PRODUCT SUPPORT PROGRAM FOR INSTALLING A GROUND WIRE FOR THE AC COMPRESSOR CLUTCH SOLENOID ON CERTAIN CT660 ON HIGHWAY TRUCKS

SERVICE LETTER

CT660 A/C COMPRESSOR GROUND REWORK

Image1.1.1

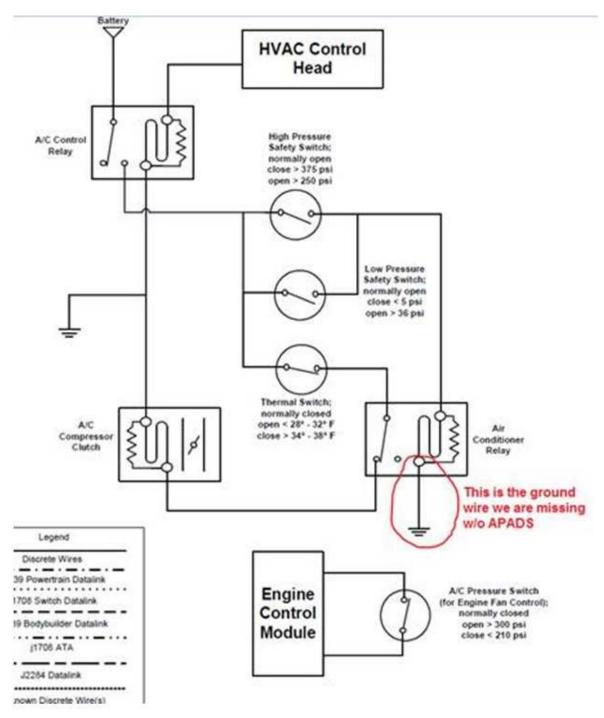
Issue: Missing ground wire to relay coil that activates/deactivates AC compressor clutch solenoid on CT660 On Highway Trucks built without APADS (Air Conditioning Protection and Diagnostic System).

Image1.3.2

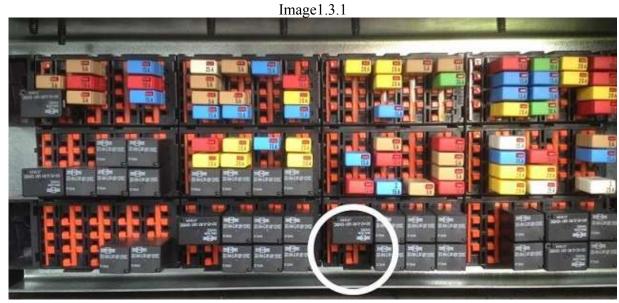
- 1) Construct terminated wire by terminated one end with 396-2900 Terminal and the other end with 396-2894 Terminal.
- 2) Locate empty cavity in FB09, cavity M1-G1. Refer to Image1.3.1 and Image1.3.2.

- 3) Remove the orange lock with a set of needle-nose pliers or similar from the front.
- 4) Remove the fuse panel mounting bolts from the feet using a socket tool.
